## 產品變更通知

### Product Change Notice

To: No. 20240912  
Date: 2024/9/12  
 Inalways P/N(華瑋/力瑋)料號 :0717-1S-PLXX/0717-1S-PQXX  
 0717-1S-PLXXN-A/0717-1S-PQXXN-A/0717-1S-PQXXN-H/0717-1S-PQXXM-A/0717-1S-PQXXI  
 0717-1S-PQXX-L/0717-1S-PQXX-S/0717-1S-PQXX-C/0717-1S-PQXX-H/0717-1S-PQXX-M  
 0717-1S-PQXX-AM/0717-1S-PQXX-C-M/0717-1S-PQXX-C-AM/0717-1S-PQXX-H-AM  
 Customer P/N(客戶料號):  
 Description(變更描述)

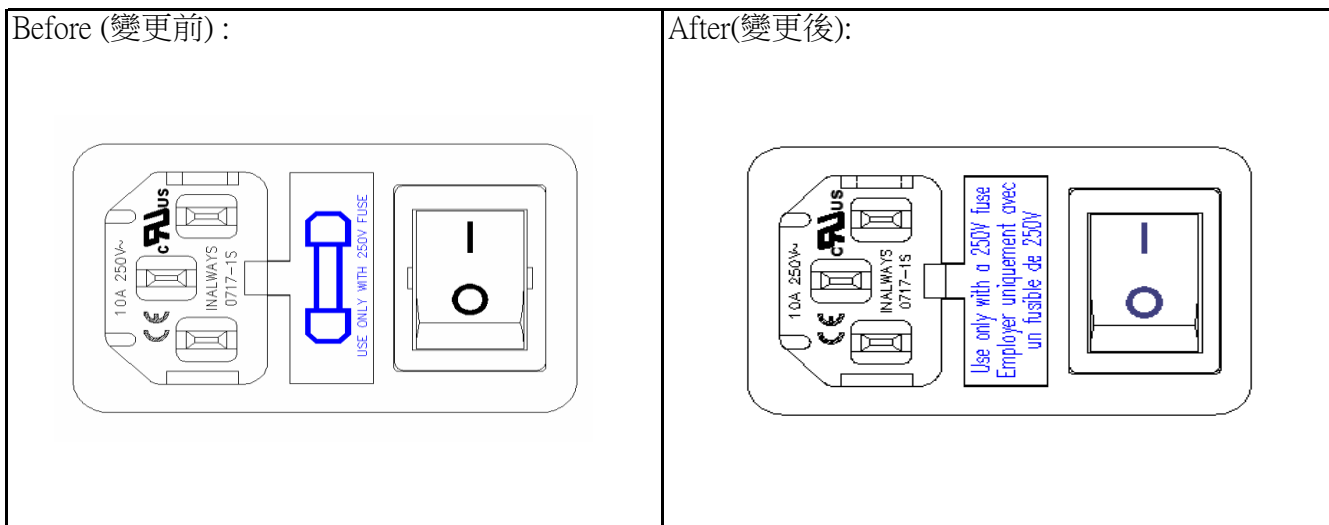
1. UL/CUL標準升級，CSA要求保險絲座刻字需同時包含英文及法文。  
 UL / CUL standard upgrade, CSA requires fuse holder inscription to include both English and French。
2. 變更後的圖紙如附件  
 The drawings are as attached files.
3. 變更刻字後的出貨將於 2025/02/05  
 The marking changes shipment will be started from 2025/02/05
